**ENVIRONMENTAL ASSESSMENT
REHABILITATION AND REPAIR
ROOT RIVER AND RUSH CREEK FLOOD CONTROL PROJECT
RUSHFORD, MINNESOTA**

**U.S ARMY CORPS OF ENGINEERS
ST. PAUL DISTRICT**

MAY 2008

62. Levee "B" – Photo of the Park Street bridge pier, missing riprap under bridge and erosion.

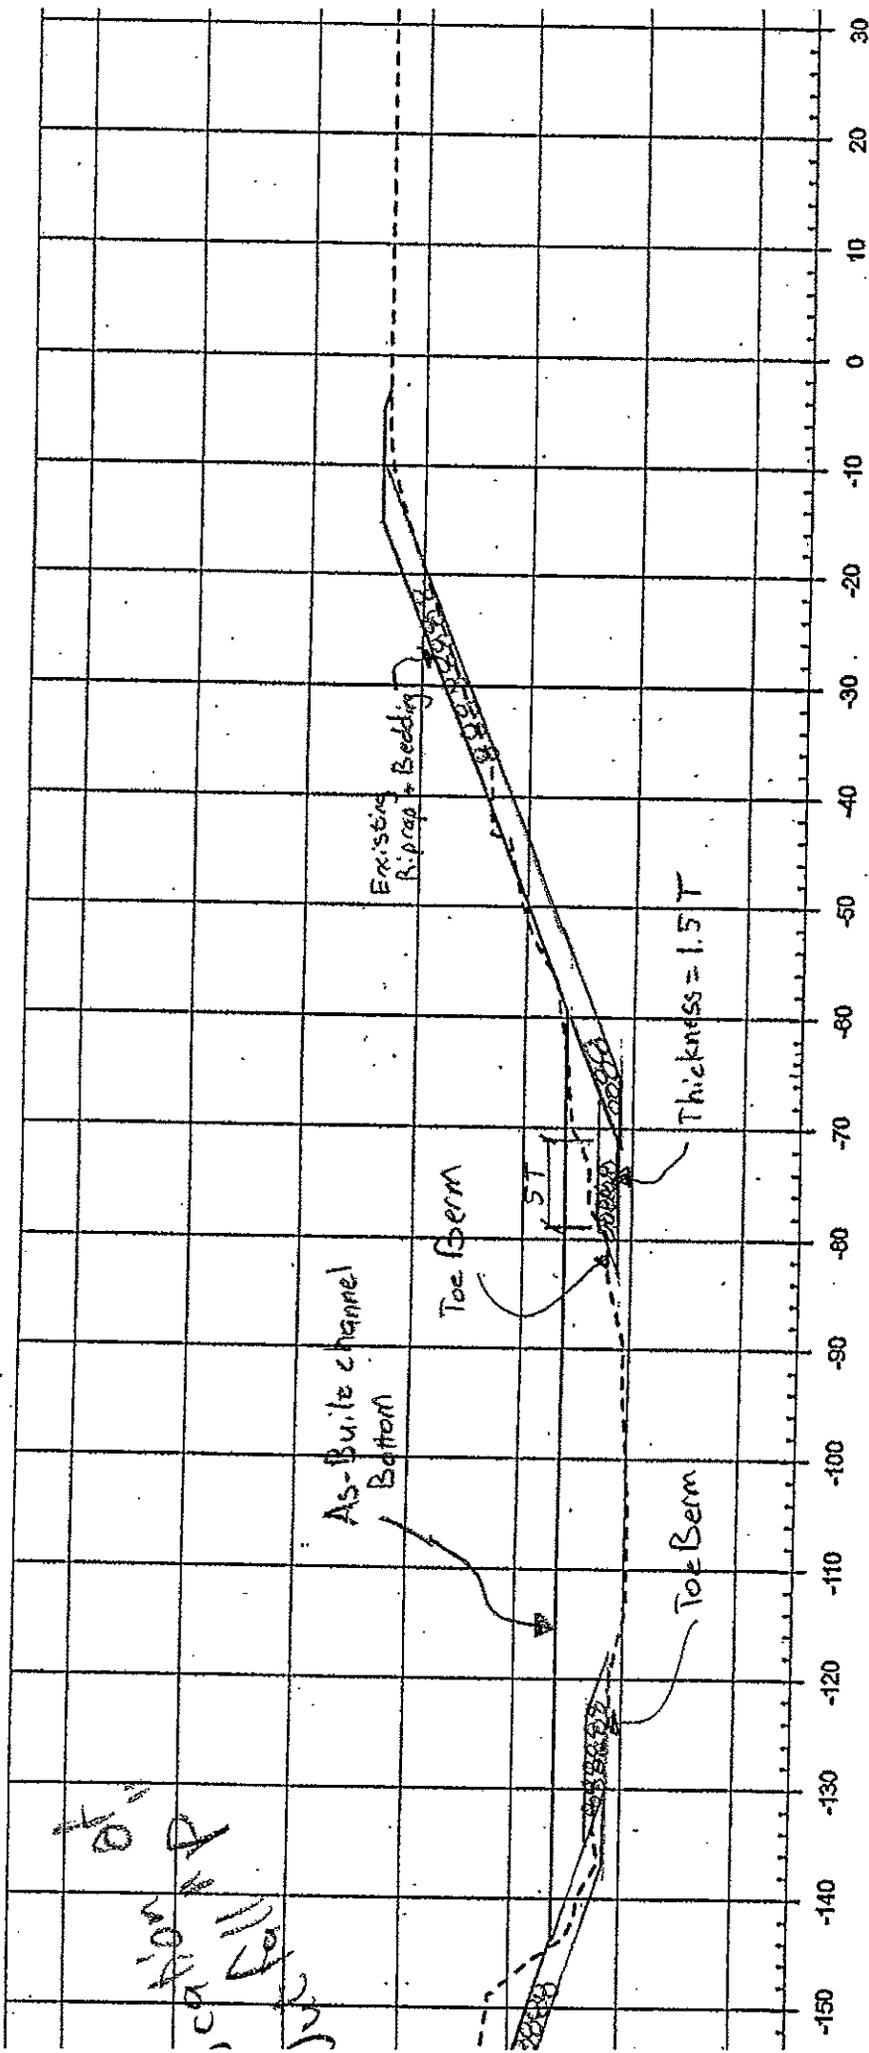
Comment – 1) Note, the height of the graffiti on the bridge pier, gives an idea of how much channel erosion occurred.

2) Like the left bridge abutment the rock protection was also displaced on the right bank under the bridge

Figure 2. Existing floodwall and portion of Walker-Valentine House to right. View to North.

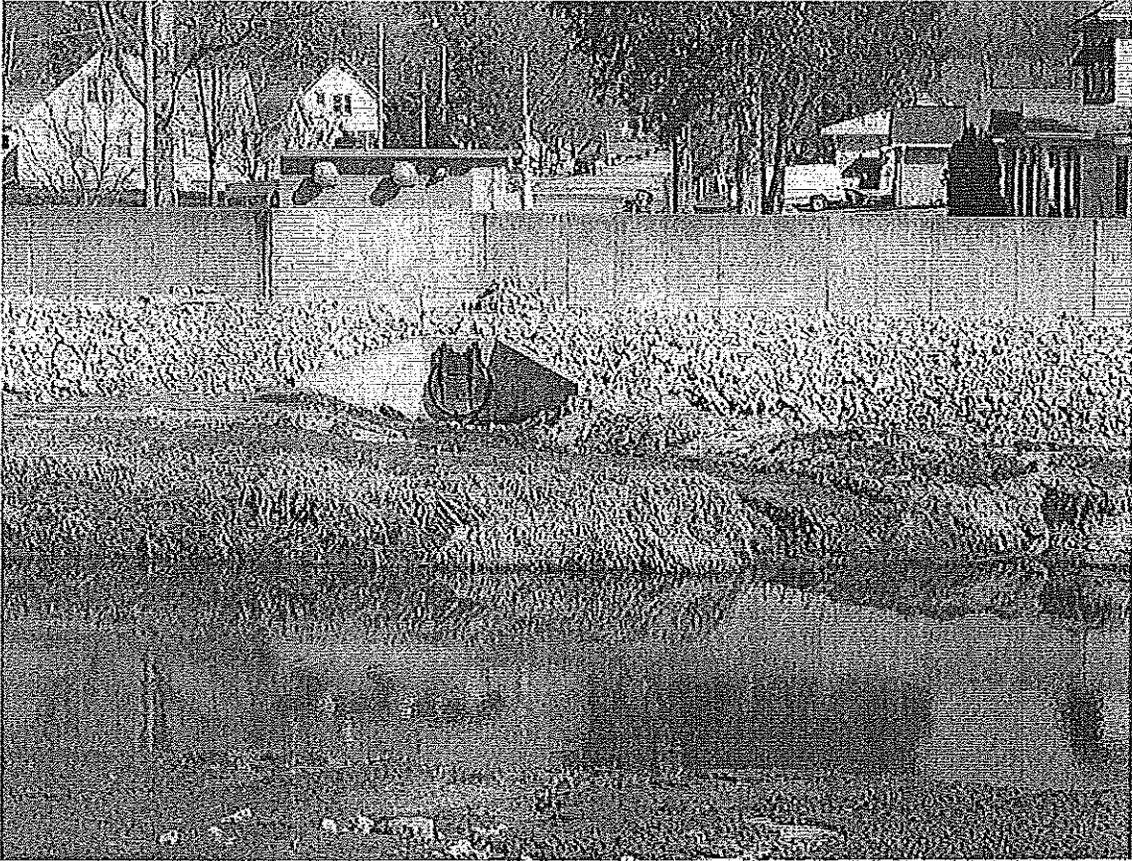
In Area B (Figure 1), near the Walker-Valentine House, extensive erosion occurred to the channel bank and the built-up sediment located between the rock protection and the creek channel leaving unstable, vertical banks along the channel. These banks will be reshaped to the original as-built 1:3 slope and the riprap replaced. However, a short section of existing floodwall is adjacent to the Walker-Valentine House. All the work in this area will occur south of the floodwall; the existing floodwall will not be modified. Figure 2 illustrates the floodwall; a portion of the Walker-Valentine House is visible on the right side of the image.
